BID ADDENDUM NO.2

CHILLICOTHE ELEMENTARY SCHOOL ADDITION

Issue Date: October 7, 2022

Project: Chillicothe Elementary School Addition
Chillicothe, Missouri

C406

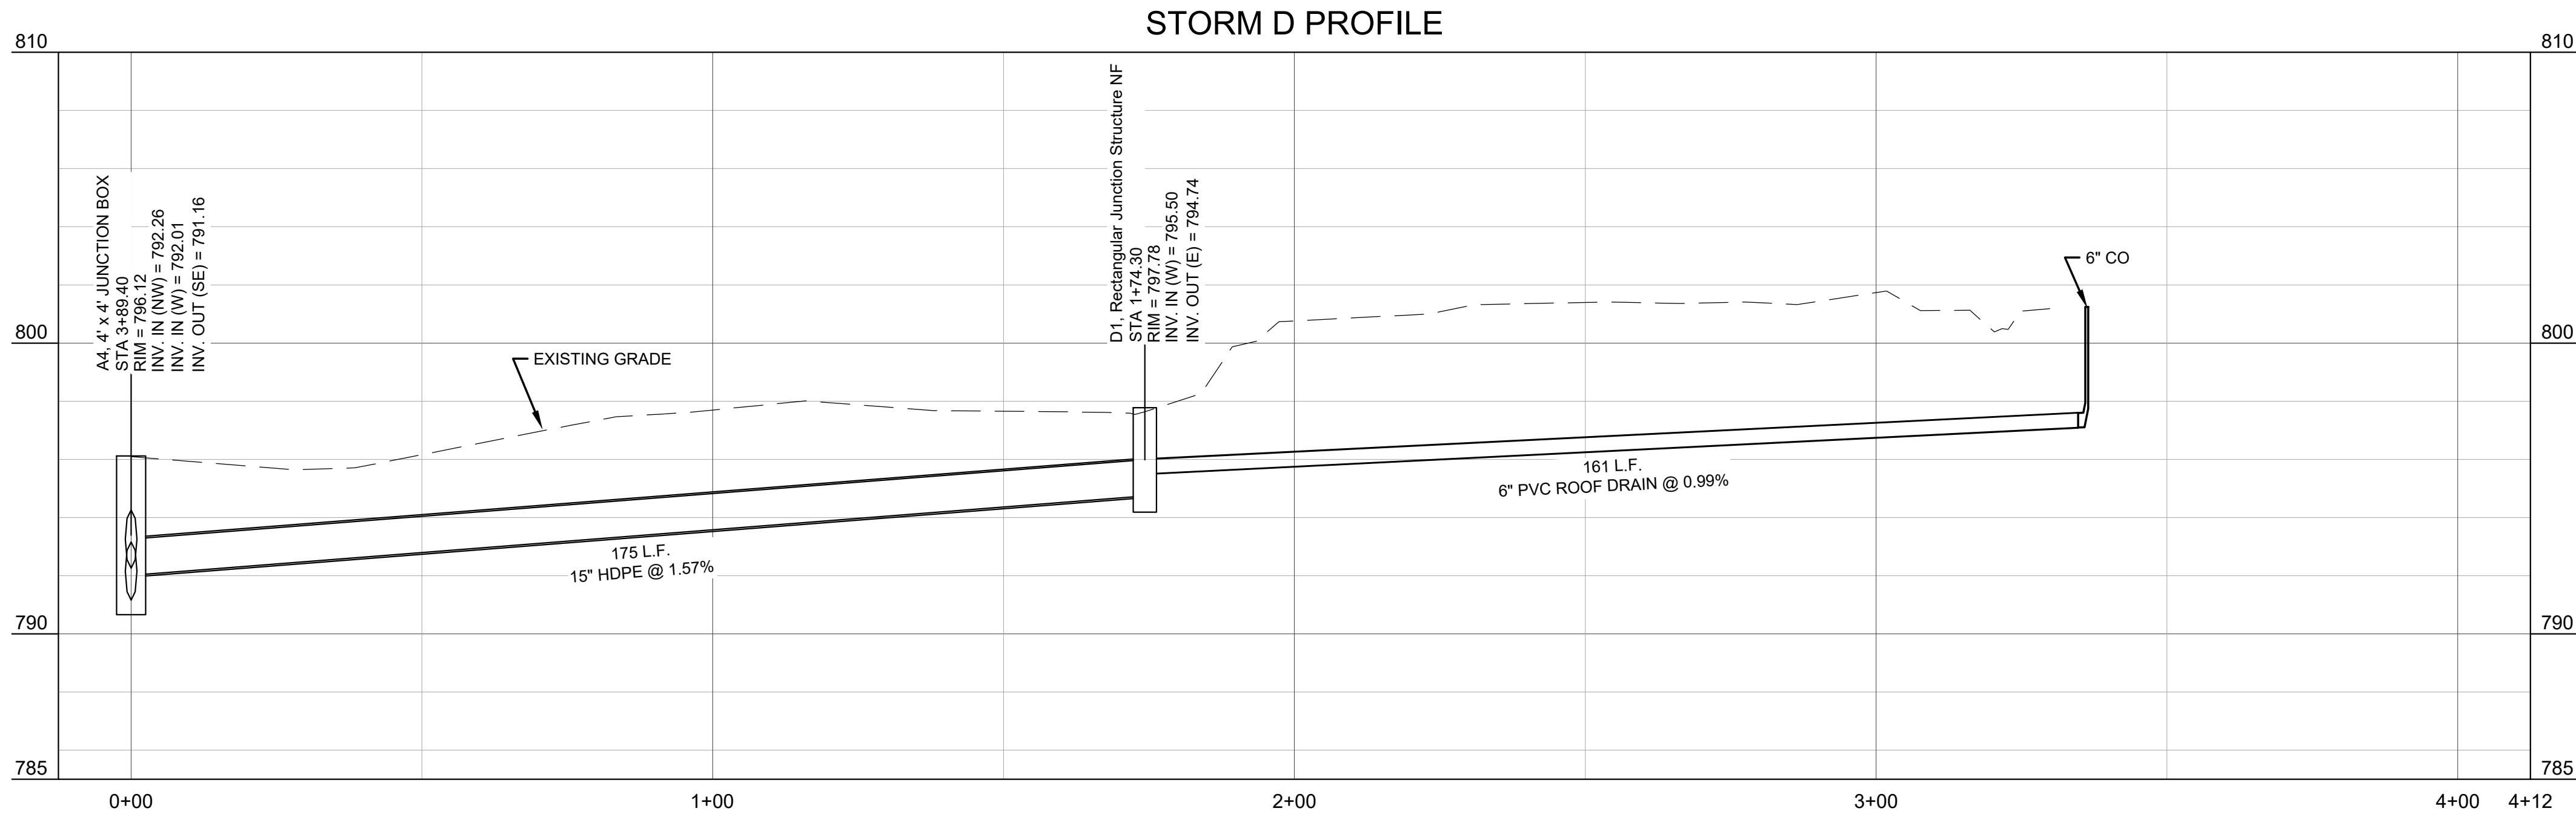
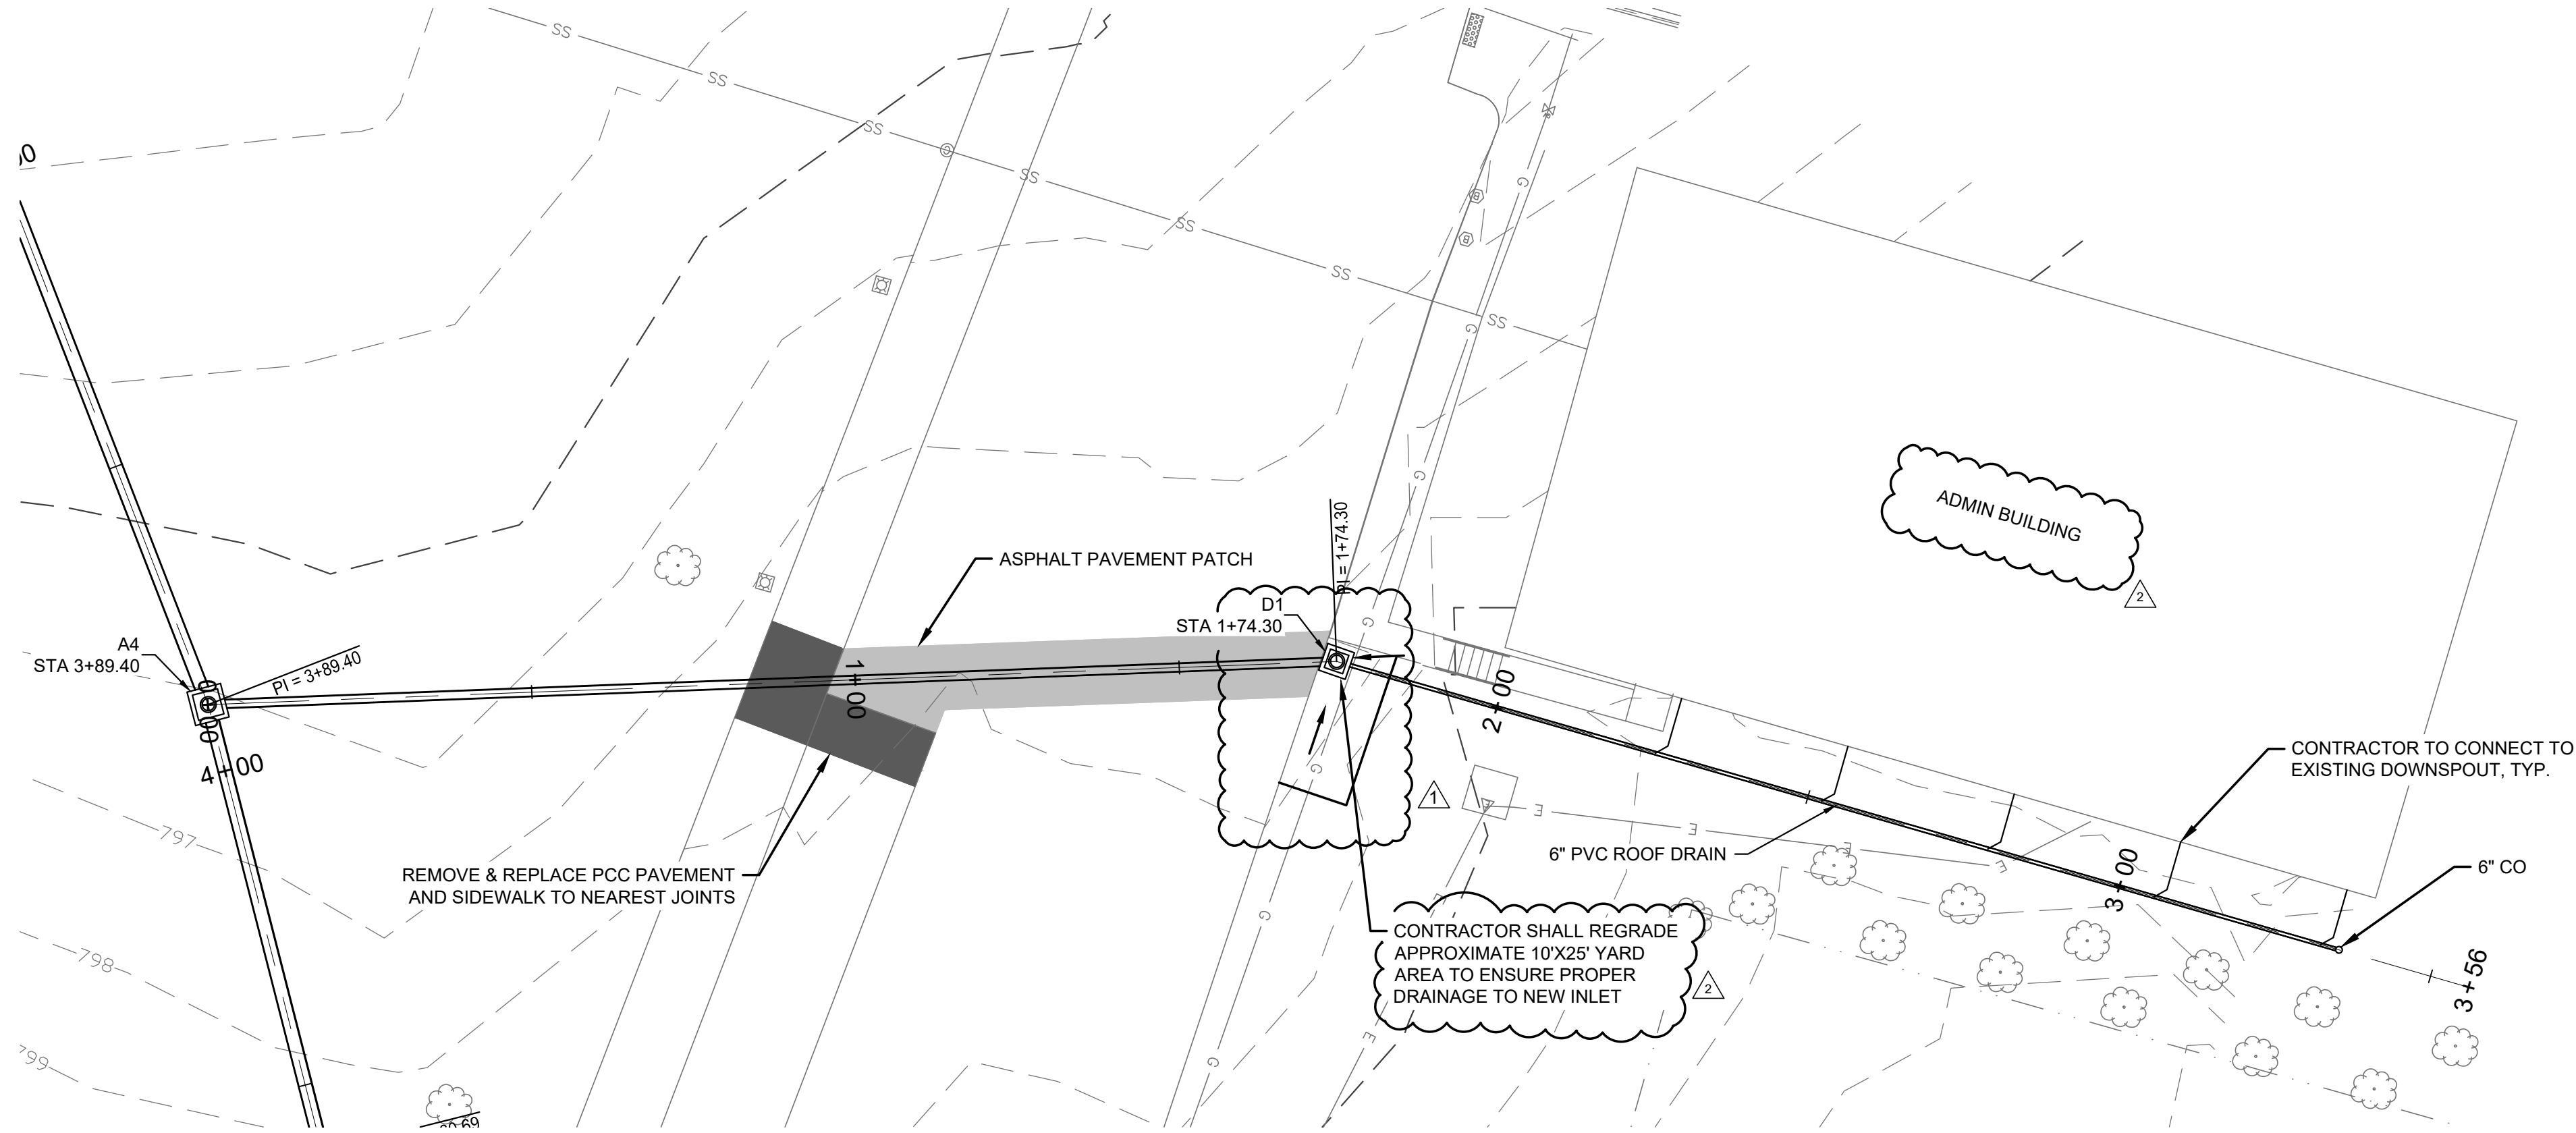
1. Question: Please clarify where the stadium parking is located?
a. Answer: Reference sheet C406 issued in this Addendum.
2. Question: What is the extent of grading that is required behind the District Administration Building?

4. SHEET C406:
 - a. CLARIFIED – A title was added to the enlarged plan clarifying that the plan is of the Stadium Parking Lot identified in Alternate NO. 5.

A018

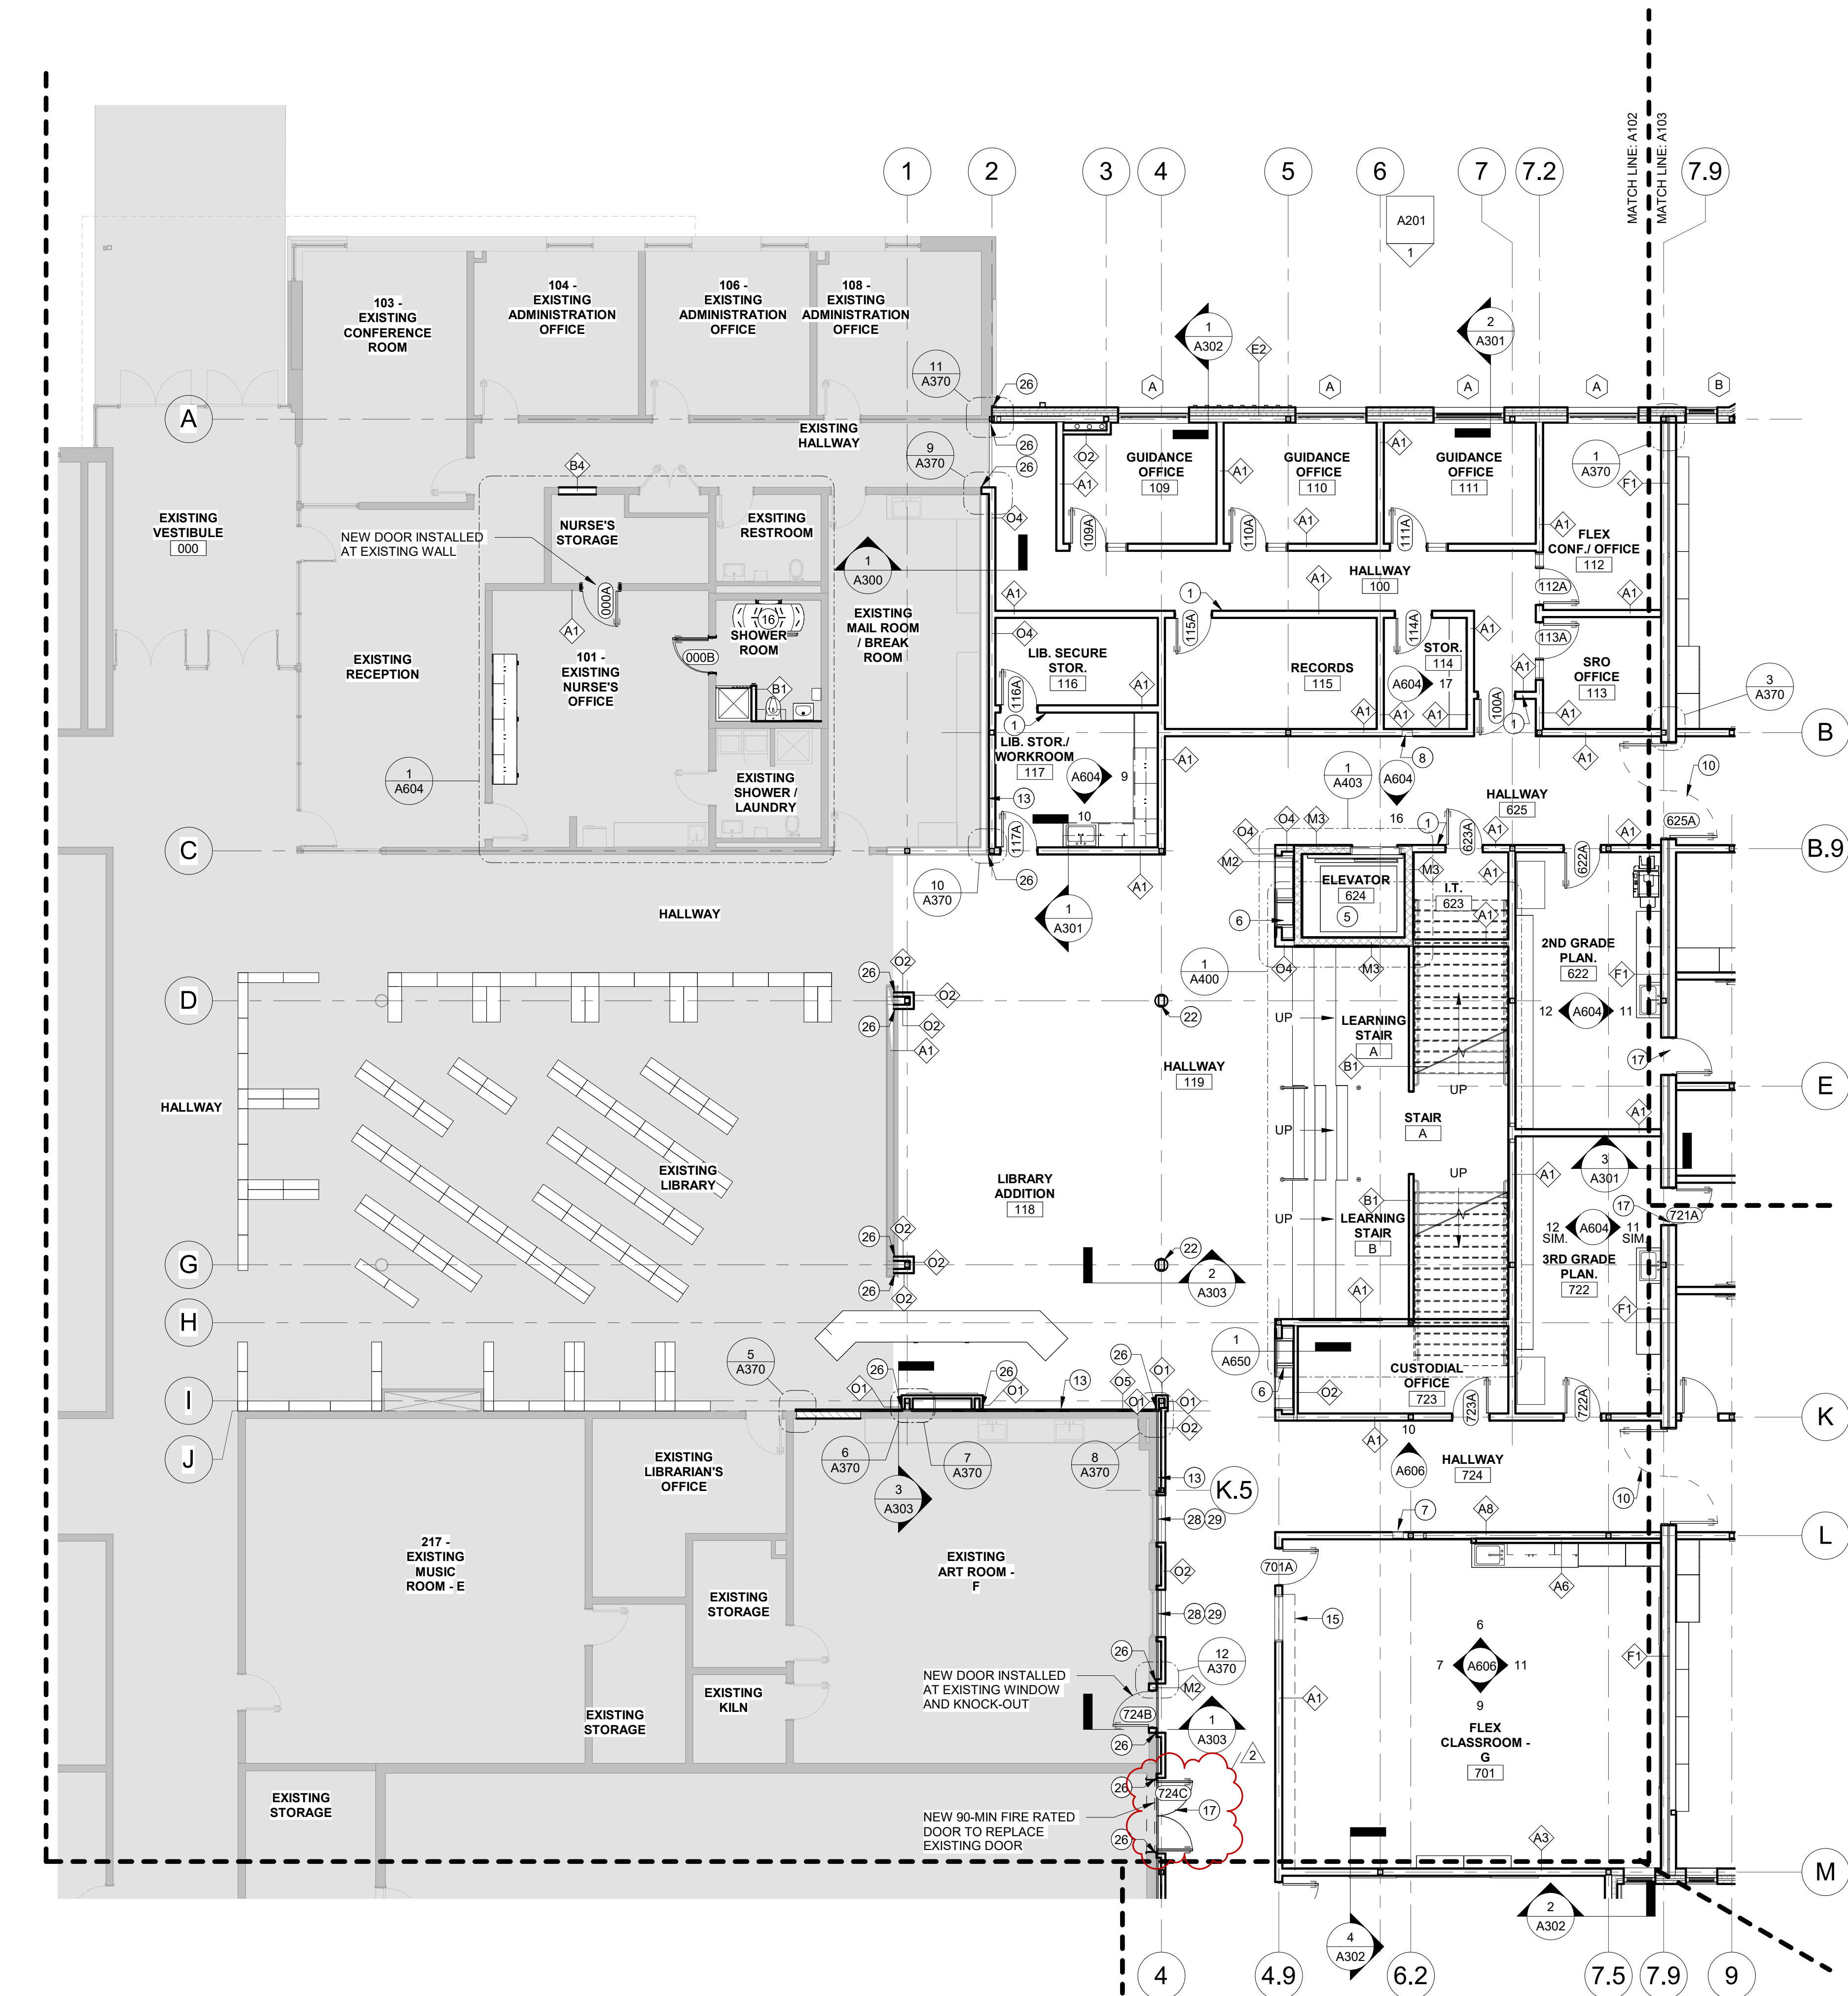
6. SHEET A018:
 - a. MODIFY – On sheet updated signage material for signage type 1-10.
7. SHEET A102a:
 - a. MODIFY – On sheet A102a, door tag 104D was modified to read 724C.
